PR/KBE/44659-001-Issue 1

**HARROGATE ROAD, WETHERBY
HYDROLOGICAL REBUTTAL REPORT**

HALLAM LAND MANAGEMENT LIMITED AND STOCKELD PARK

This report has been prepared by me Dr Keith Emmett on behalf of the Appellants (Hallam Land Management Ltd and Stockeld Park) in response to the submitted document Planning Appeal – Proof of Evidence (PoE) by David Howard on behalf of Better Wetherby Appeal Ref: APP/E2734/W/193236153.

Geological map key

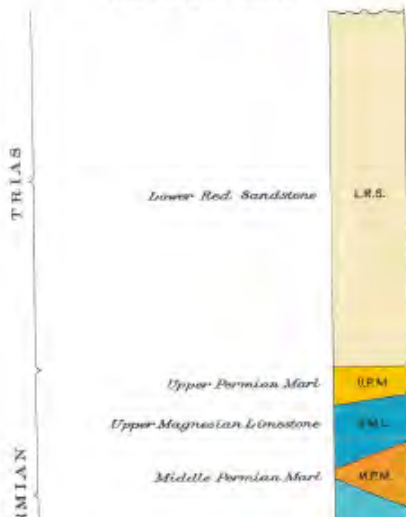
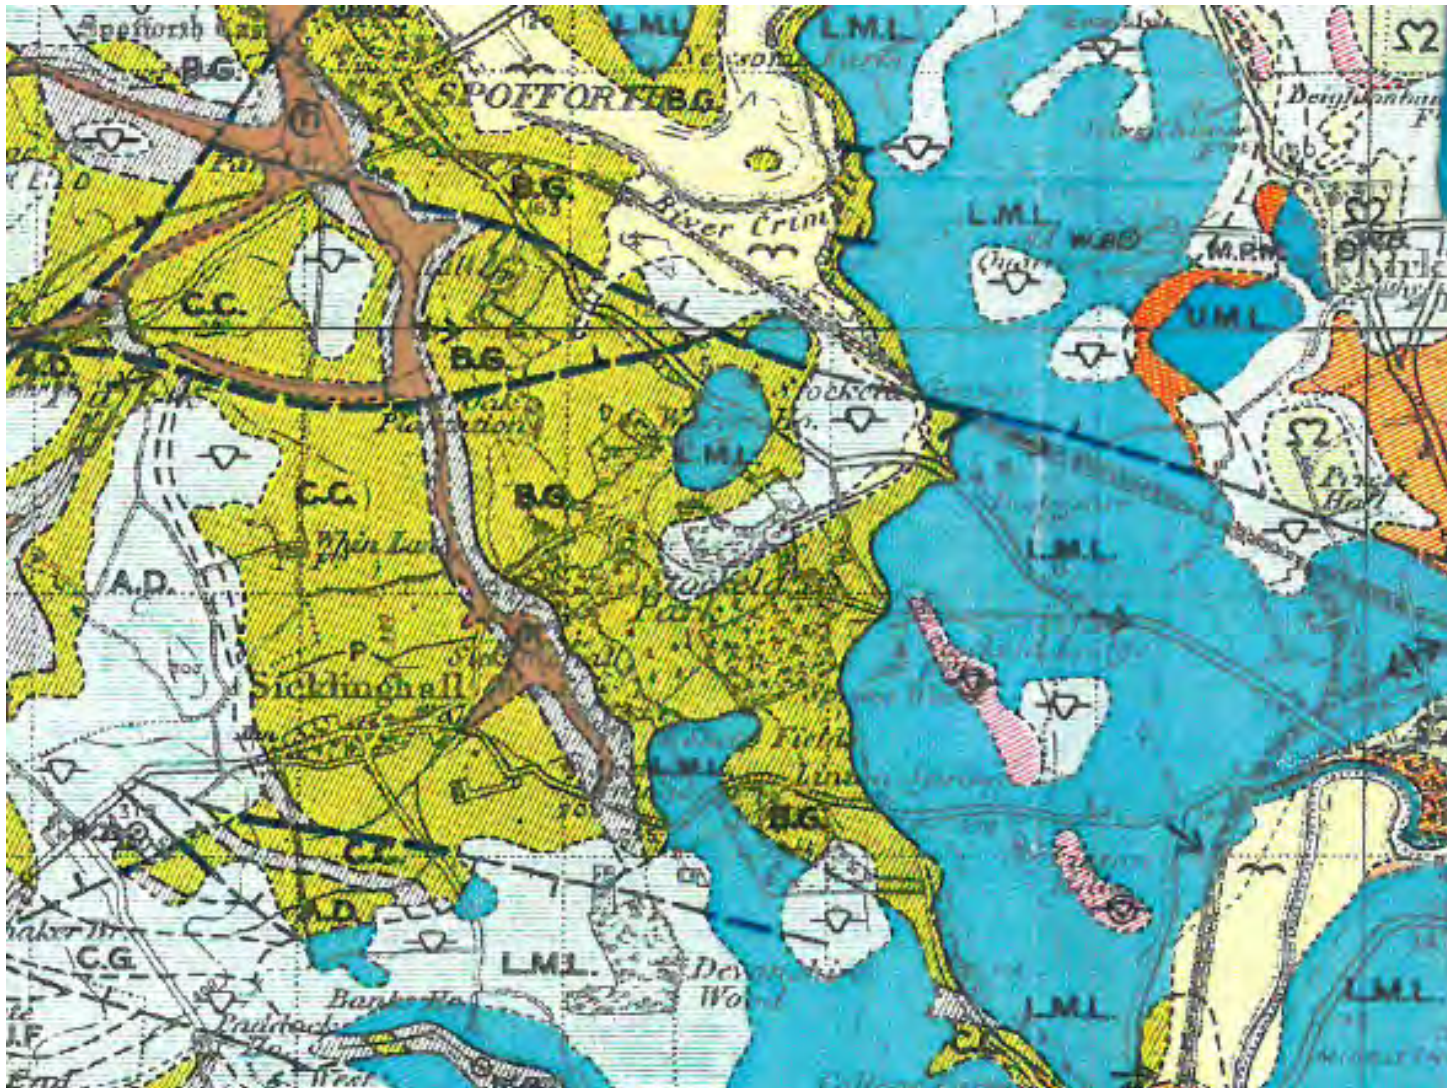
The proposed development site lies over Lower Magnesium Limestone (LML) bedrock with a south easterly plunge (dip direction) as identified in Geological Map, Sheet 70 (Appendix 3). A fault is indicated north of Harland Way with a downthrow on the north side of the fault. The fault does not alter the plunge of the bedrock. The north western area of the SAC / SSSI is located on Middle Permian Marl (MPM) with the main body of the SAC / SSSI on Upper Magnesium Limestone (UML) (Appendix 3). Superficial deposits of Boulder Clay are shown to exist in the centre line of the SAC / SSSI directed in a north west to south easterly alignment.

Item 2.2 – The Geological maps show the plunge (dip direction) of the underlying Limestone bedrock to be in a south easterly direction. The East - West fault line shows a downthrow indicating the dropping of the bedrock north of the fault. The fault does not alter the direction of the dip, therefore groundwater flow remains in a south easterly direction towards the Wetherby and the River Wharfe (Appendix 3).

Item 3.3 – See point 2.2. The argument is incorrect as the geological maps show the plunge to be south easterly.

Extract OS plan showing indicative Kirk Deighton SSSI catchment

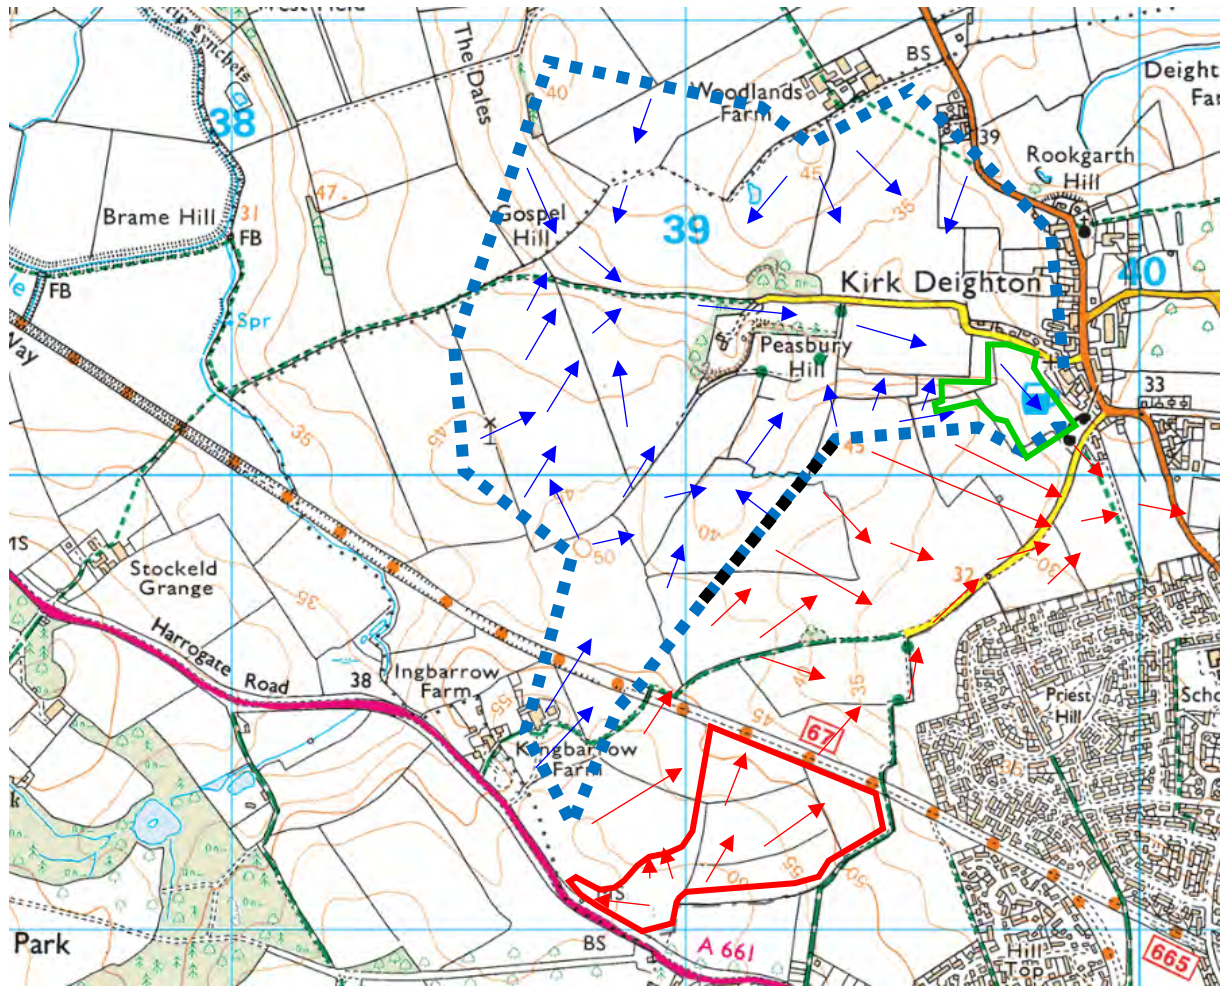
The surface water runoff and catchment plan in Appendix 4 highlights the surface water runoff routes which flow perpendicular to the land contours. It can be seen that the indicative SAC/SSSI catchment provided in the original hydrological report is representative of the overland flow paths (represented by blue arrows) that provide surface water recharge to the ponds and Great Crested Newt (GCN) habitat. Surface water runoff from the proposed development can be seen to contribute to a different catchment (represented by red arrows) flowing south of the SAC / SSSI and joining natural flow routes into west Wetherby.

Figure 1: Surface Water Drainage

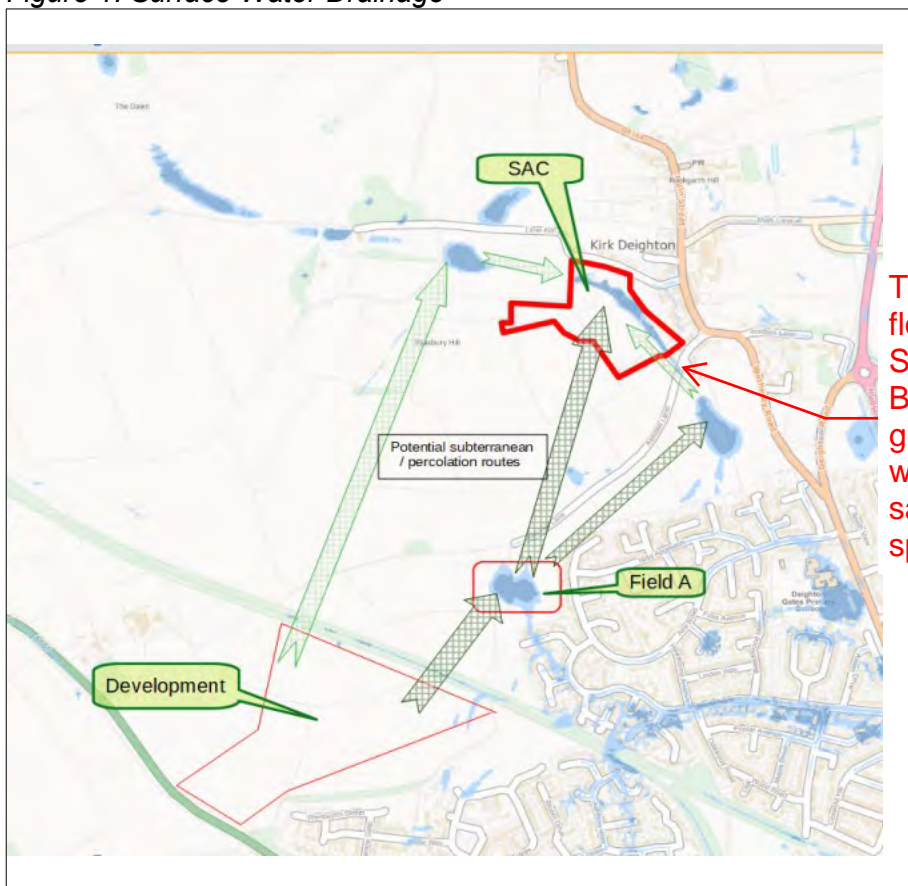
Figure 1: Should read "Flood Risk from Surface Water". The map does not represent standard drainage but worse case scenarios resulting from saturated soil, thus indicating surface runoff collection points.

A1.2 – Surface water is shown to flow uphill from the pond north east of the “Field A” (Appendix 6). This is incorrect and would also imply groundwater emergence through the valley. Strategic Flood Risk Assessment maps show there to be <25% risk of groundwater emergence on the site. Furthermore, the PoE states that there are no such features in Item 3.6.

This indicates that water flows uphill towards the SAC/SSSI.
Below ground this implies ground water emergence, which BW Issue 3.6 has said does not occur (i.e. springs)
